PLANNING CLEARANCE
 (Single Family Residential and Accessory Structures)
Community Development Department

BLDG PERMIT NO. 90445

BLDG ADDRESS 364 1/2 Ridge Cr. Dr. SQ. FT. OF PROPOSED BLDGS/ADDITION 2368
 TAX SCHEDULE NO. 2945-201-05-031 SQ. FT. OF EXISTING BLDGS N/A
 SUBDIVISION Ridges TOTAL SQ. FT. OF EXISTING & PROPOSED ~~N/A~~ 2368
 FILING 4 BLK 12 LOT 31C
 NO. OF DWELLING UNITS:
 Before: 1 After: one this Construction
 NO. OF BUILDINGS ON PARCEL
 Before: 1 After: one this Construction
 (1) OWNER Raymond C. + Mary Ellen Davis
 (1) ADDRESS P.O. Box 451 Grand Jct, Co 81502
 (1) TELEPHONE 970 242 5890
 (2) APPLICANT Same
 (2) ADDRESS _____
 (2) TELEPHONE _____
 USE OF EXISTING BUILDINGS N/A
 DESCRIPTION OF WORK & INTENDED USE Residence
 TYPE OF HOME PROPOSED:
 Site Built _____ Manufactured Home (UBC)
 _____ Manufactured Home (HUD)
 _____ Other (please specify) _____

PROPOSED 2882 # S.F.R.

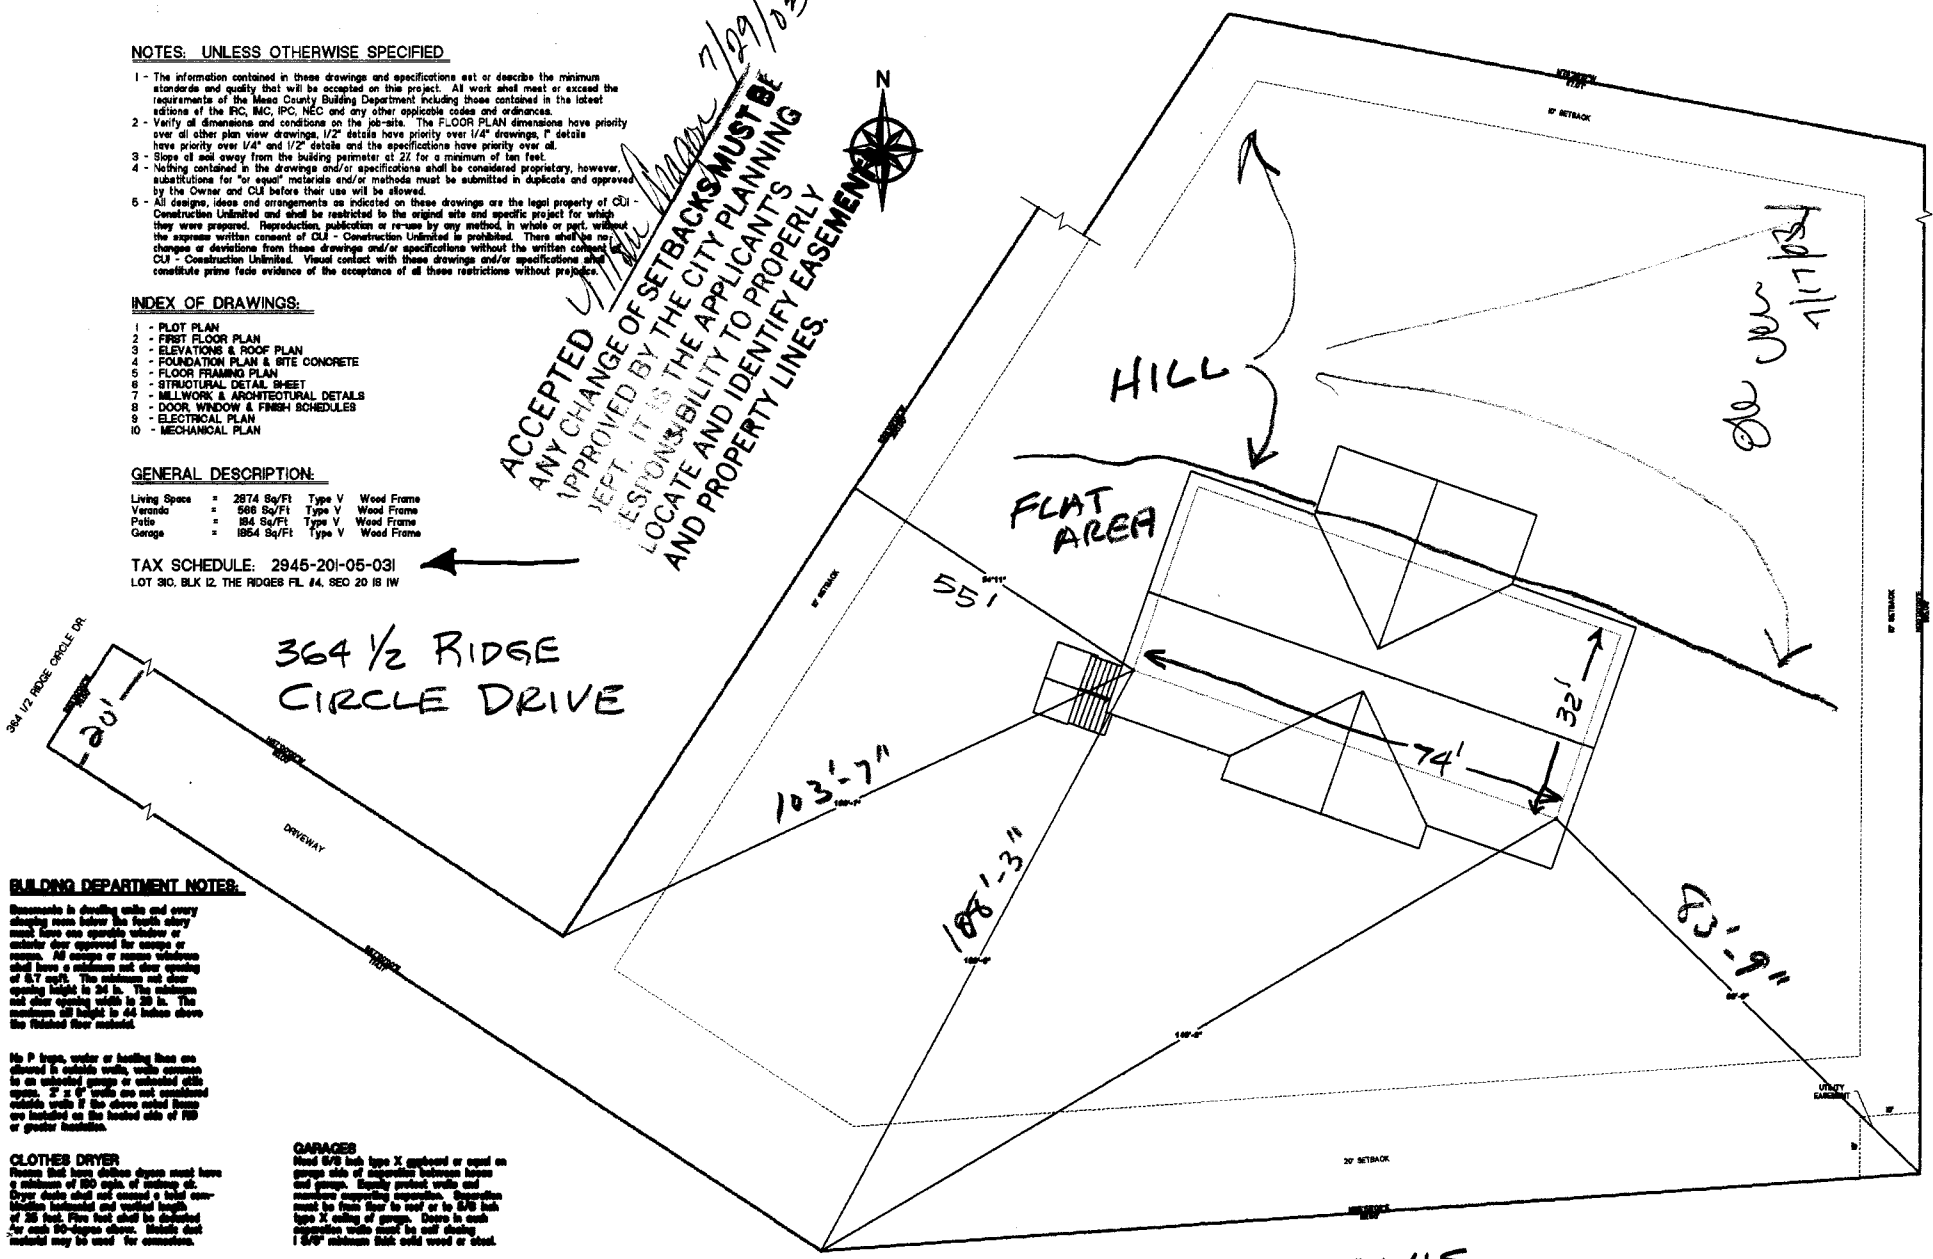
ACCEPTED *7/29/03*
 ANY CHANGE OF SETBACKS MUST BE APPROVED BY THE CITY PLANNING DEPT. IT IS THE APPLICANTS RESPONSIBILITY TO PROPERLY LOCATE AND IDENTIFY EASEMENTS AND PROPERTY LINES.

Screening in double walls and every sliding glass door for south elevations must have one operable window or exterior door approved for escape or rescue. All escape or rescue windows shall have a minimum net clear opening of 5.7 sq ft. The minimum net clear opening height is 36 in. The minimum and other opening width is 20 in. The maximum sill height is 44 inches above the finished floor surface.

No P traps, water or heating lines are allowed in outside walls, walls adjacent to an unheated garage or unheated attic space. 2" x 4" walls are not conditioned outside walls if the above noted items are located on the heated side of 10' or greater location.

CLOTHES DRYER
 Rooms that have clothes dryer must have a minimum of 100 sq ft of ceiling air. Cover doors shall not exceed a total combined horizontal and vertical length of 20 feet. Five feet shall be deducted for each 50-square degree ductless duct material may be used for connection.

GARAGES
 Wood GFI lock type X enclosed or equal in garage side of separation between house and garage. Regularly spaced walls and ceiling separating exterior. Separation must be from floor to roof or to 6'6" but type X ceiling of garage. Doors in each separate walls must be double door 1'6" minimum door solid wood or steel.
